GUADALUPE RIVER BASIN, TEXAS

DESIGN MEMORANDUM NO. 9C  
(REVISED DECEMBER 1970)

UPDATED MASTER PLAN  
CANYON RESERVOIR  
GUADALUPE RIVER, TEXAS

ENGOW-PV (SWFED-P 4 Feb 71) 4th Ind  
SUBJECT: Canyon Dam and Reservoir, Guadalupe River, Texas, Design  
Memorandum No. 9C (Revised December 1970)

GUADALUPE RIVER BASIN, TEXAS  
CANYON RESERVOIR  
GUADALUPE RIVER TEXAS  
**CANYON PARK**

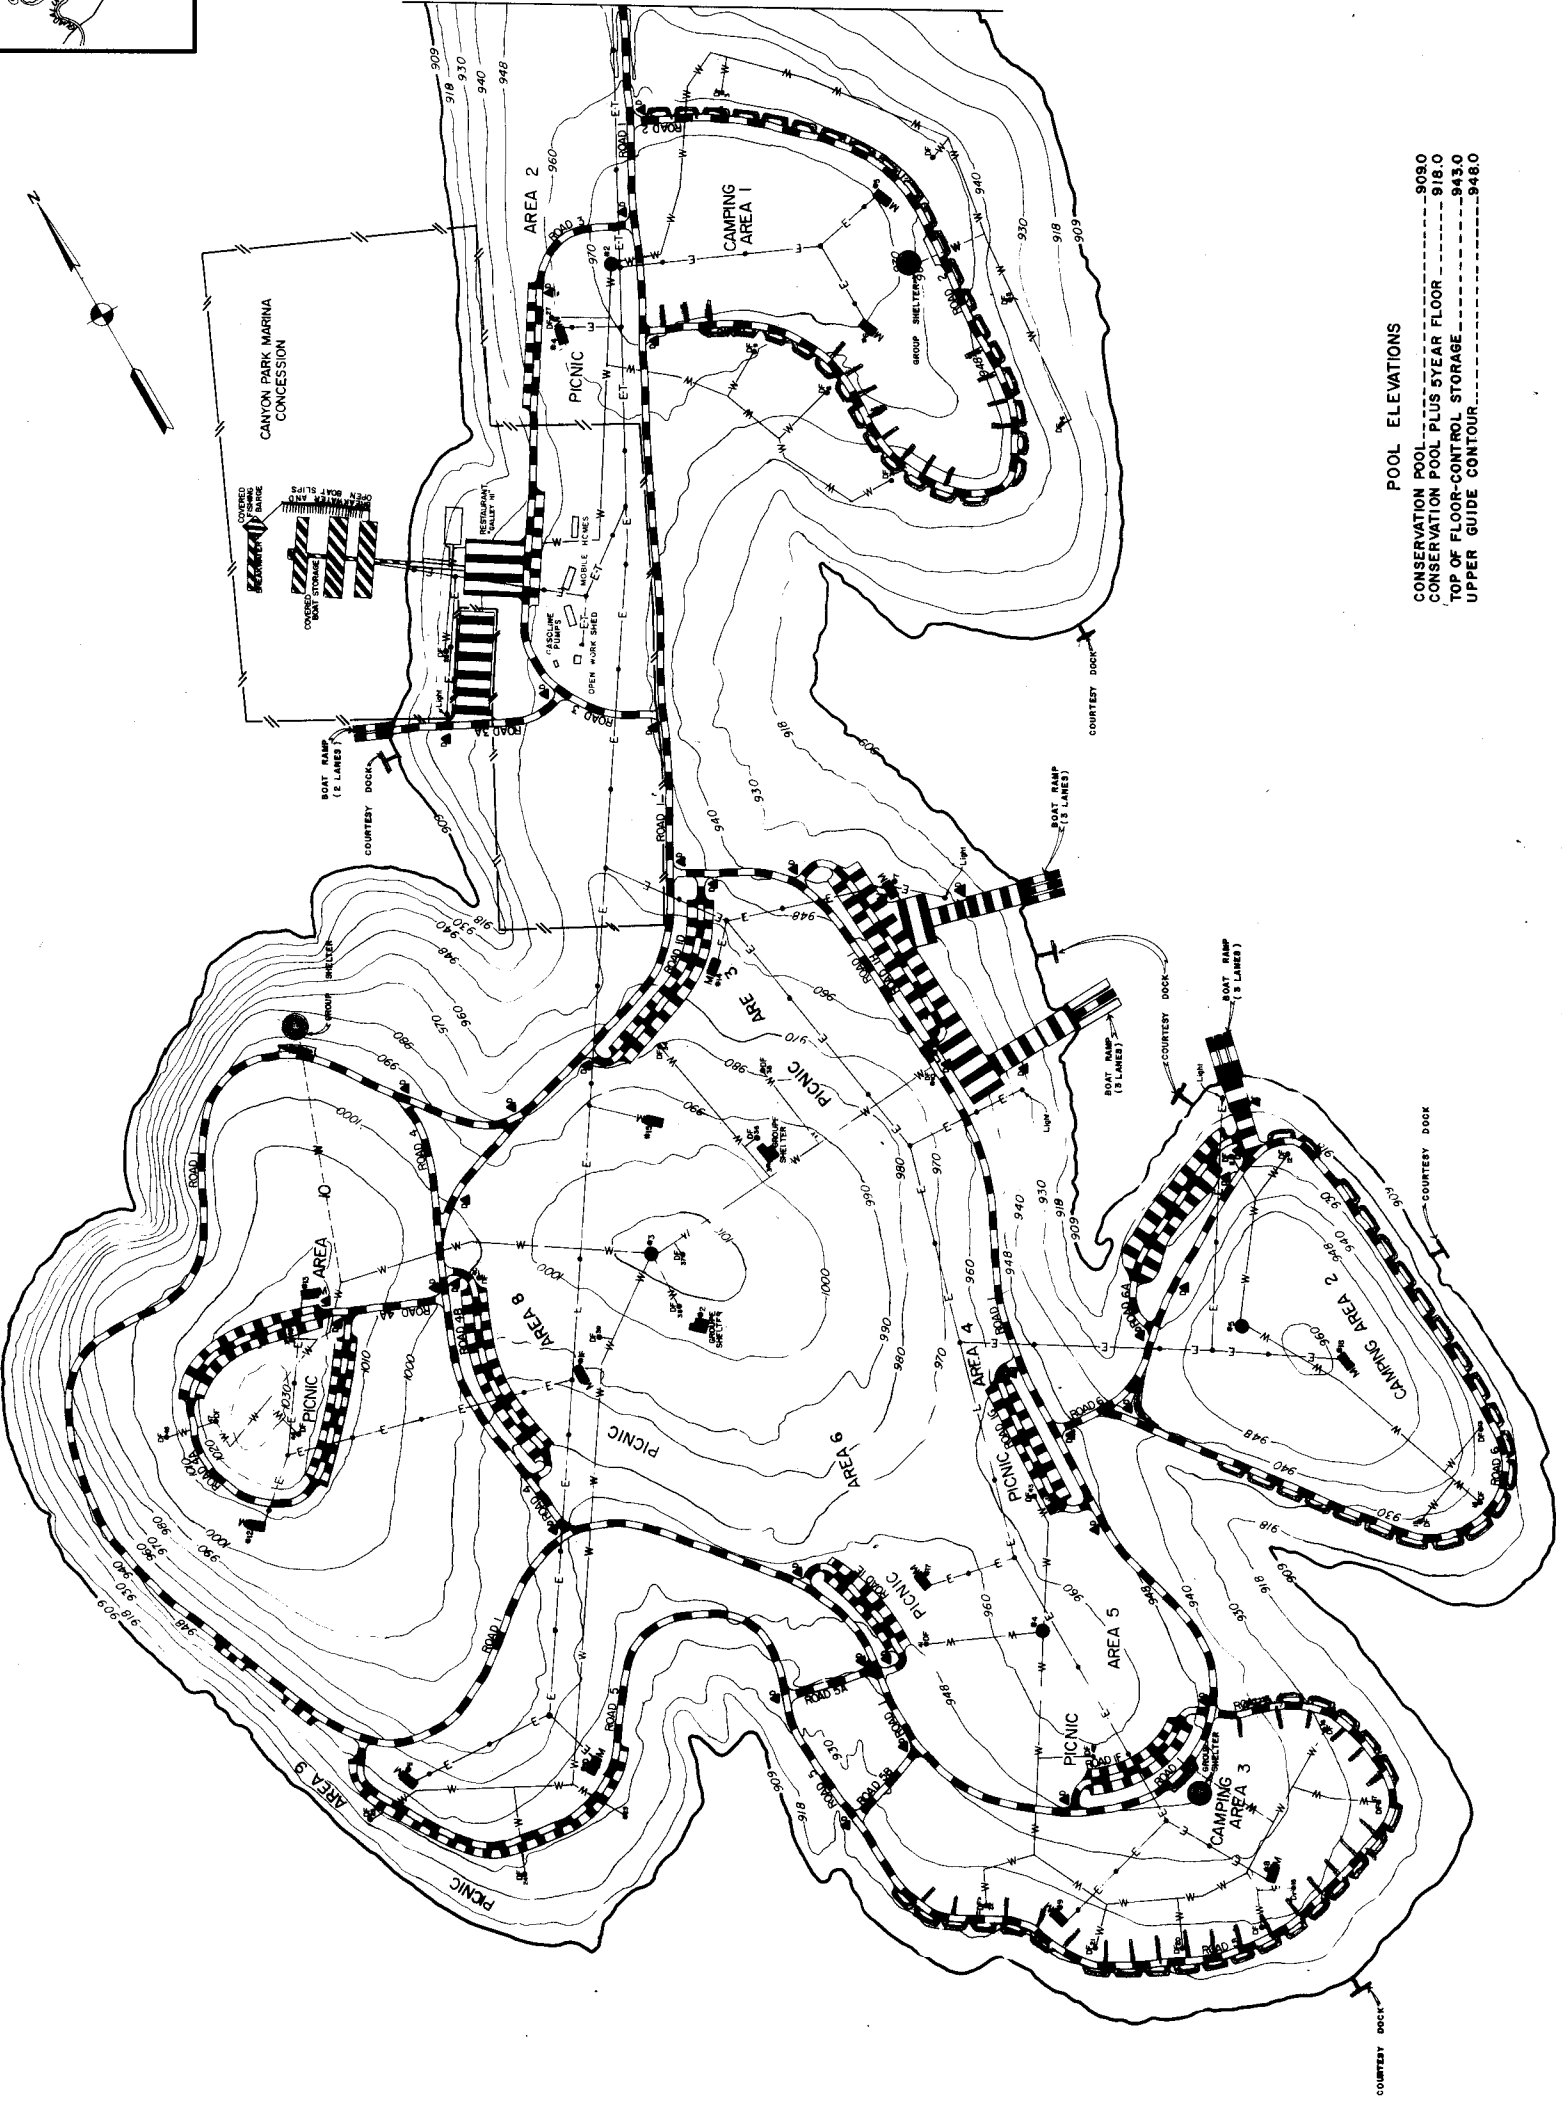
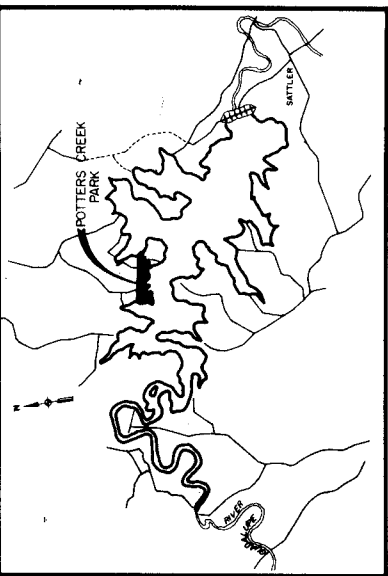
d. Paragraph 4-06. Subparagraphs a. through h. should be expanded to more definitely describe and explain existing and proposed development. Vis-a-vis paragraph 4-06c., plates 10 and 18, and Table 4, Appendix A, do not relate to each other on proposed development. Plate 10 indicates the construction of camping units FY 71 through FY 80 while Plate 18 and Table 4, Appendix A indicate these facilities as existing.

GUADALUPE RIVER BASIN, TEXAS  
CANYON RESERVOIR  
GUADALUPE RIVER, TEXAS  
CRANES MILL PARK

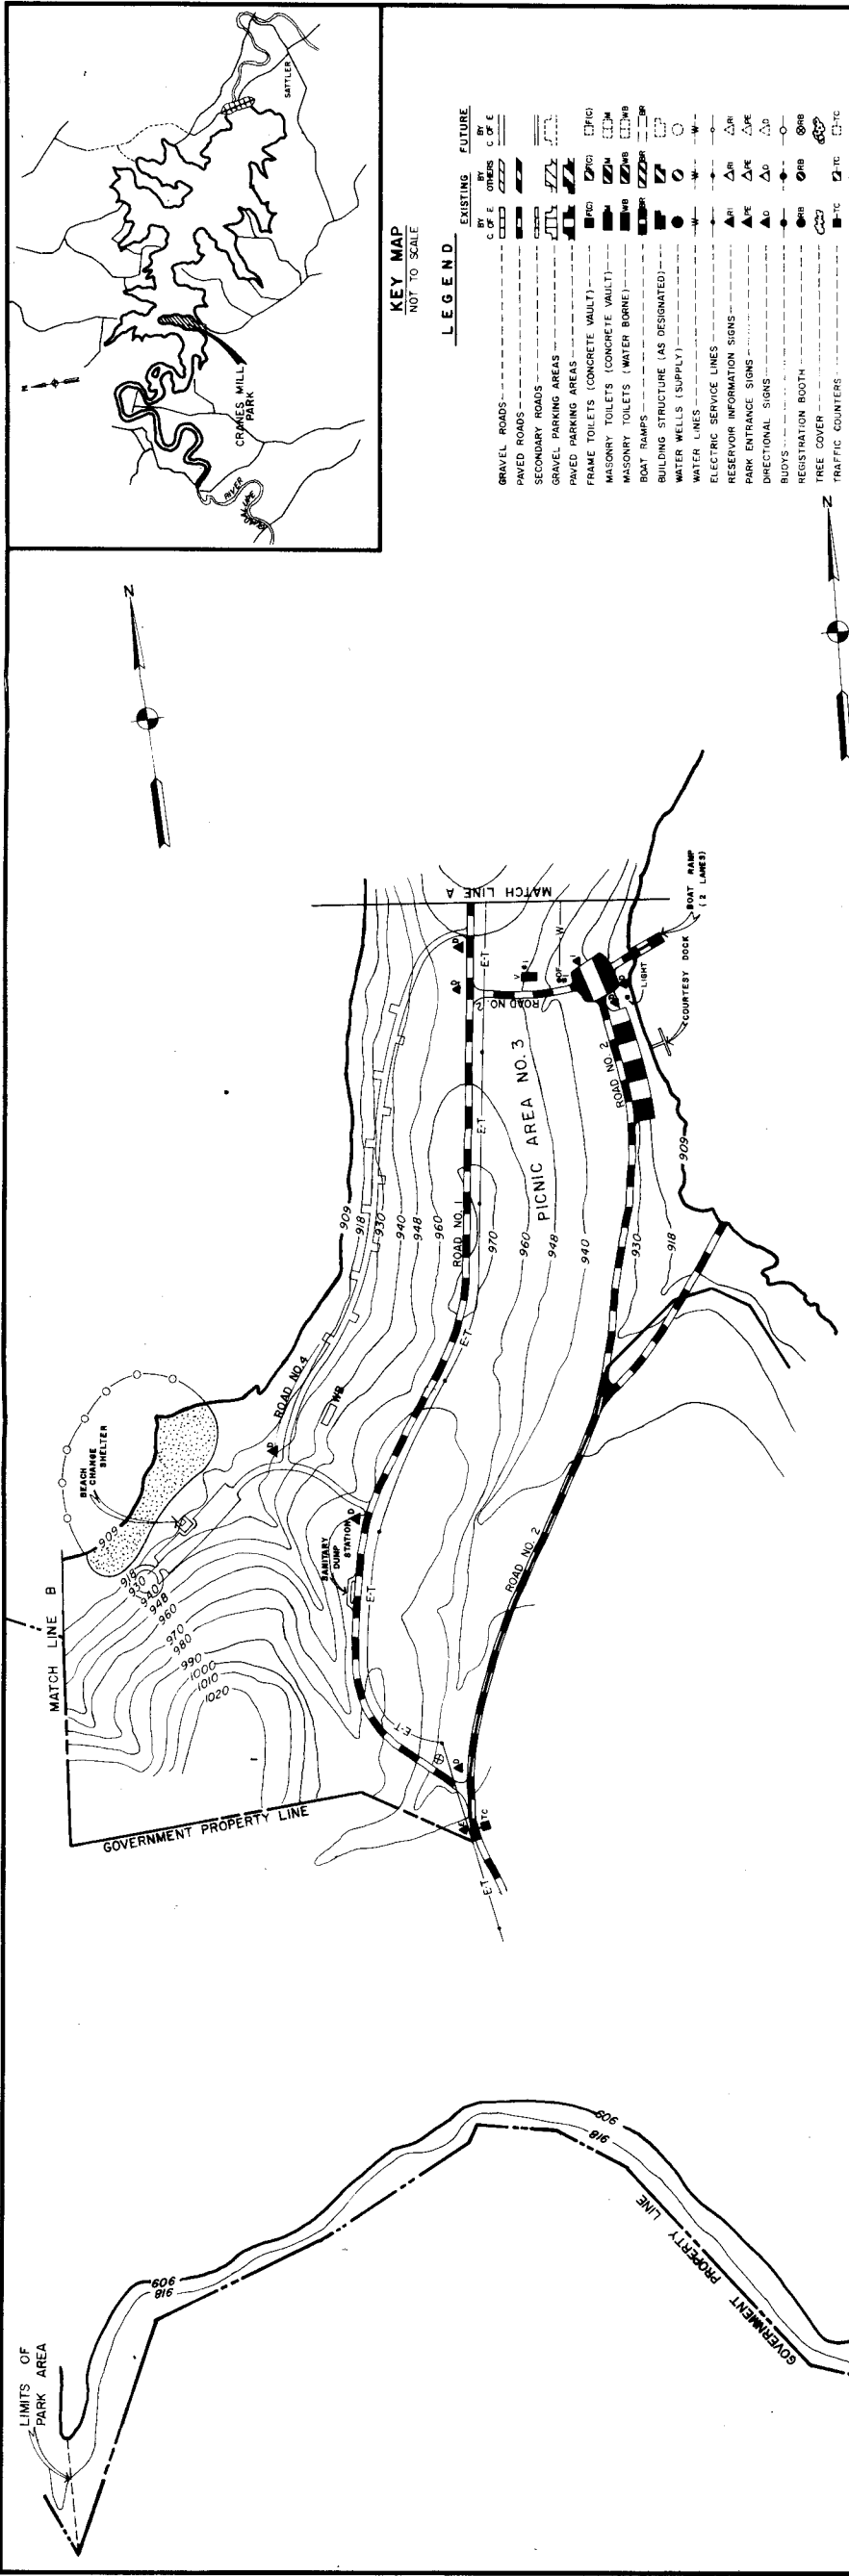
f. Plate 12, Cranes Mill Park. Consideration should be given to restudying the area with a view to making the entire peninsula north of the concession access road a camping area, with picnic expansion or replacement to the south. The existing ramp would be utilized only by campers. The proposed ramp, if required, should be relocated to the picnic area.
